**Responses to Issues Raised in Correspondence from Calga Peats Ridge Community Group Inc,
dated 9 September 2013**

These responses have been compiled principally by Dundon Consulting, the author of the independent groundwater audit incorporated in the 2012 AEMR.

Figure 3.1
**LAND OWNERSHIP AND
SURROUNDING RESIDENCES**

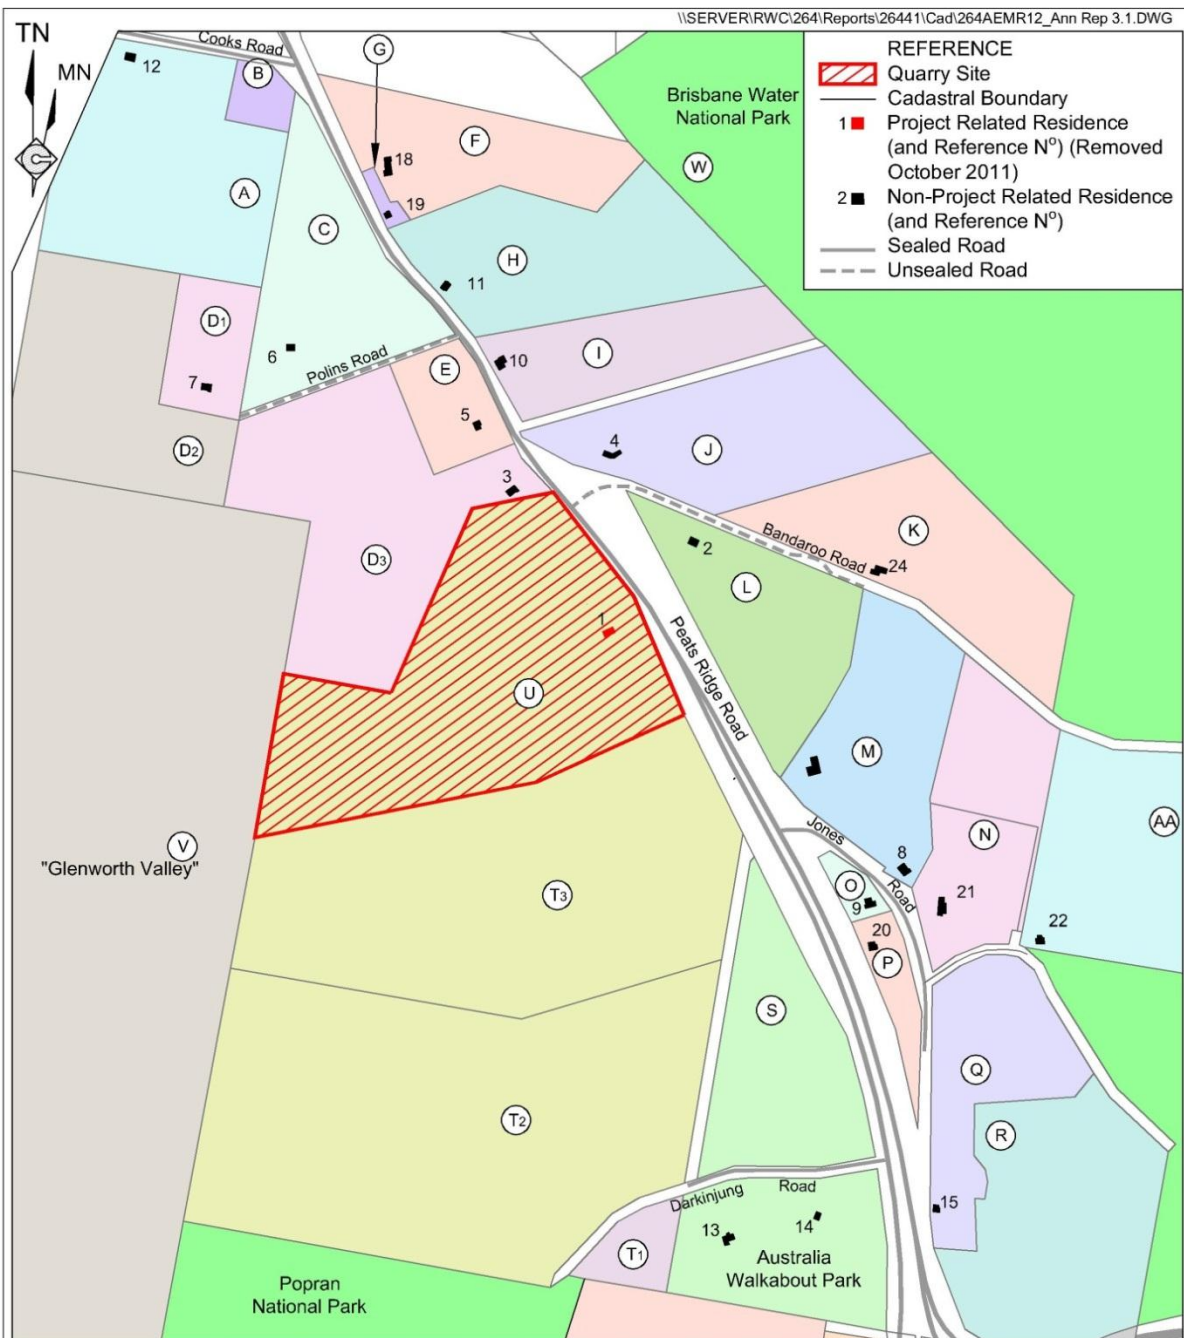
3. As soon as the magnitude of impact had been determined upon Bores CQ10 and CQ11, Rocla notified the occupier of the subject property (Property "D3") (the former landowner) and attempted to contact the new landowner for permission to re-test Bore CP3 (See Figure 3.1 - attached) in accordance with the Site Water Management Plan (SWMP) which was prepared pursuant to Consent Condition 19 of Schedule 3 (referred to as Condition of Consent 3-19 in the CPR letter). The magnitude of impact observed to date (of 0.7m) at the only affected private water supply bore (CP3 – the Gazzana domestic bore) is not considered sufficient to have any detectable impact on the bore's yield capacity. There has not been any "damage" to the bore, or to any other landholder's bore. Notwithstanding this, arrangements are in hand to re-test Bore CP3, which is a mandatory response action triggered by the detected drawdown due to sand extraction of more than 1.0m at bores CQ10 and CQ11 (see Section 6.4.1 on page 25 of the SWMP).

Rocla did make contact with the landowners of all three properties mentioned in the CPR letter (i.e. properties "O", "J" and "C". Only one landowner, Mrs King (Property "J"), indicated she had a bore on her property but declined Rocla's invitation to monitor the water level and water quality at the subject bore. Both Mr White (Property "O") and Ms Townsend (Property "C") advised Rocla that they did not accept Rocla's invitation to monitor any groundwater bores on their property. Rocla is happy to again contact all landowners surrounding the Calga Quarry to establish the existence of any additional bores, whether they were in existence at the time of the 2004 EIS or are new bores.
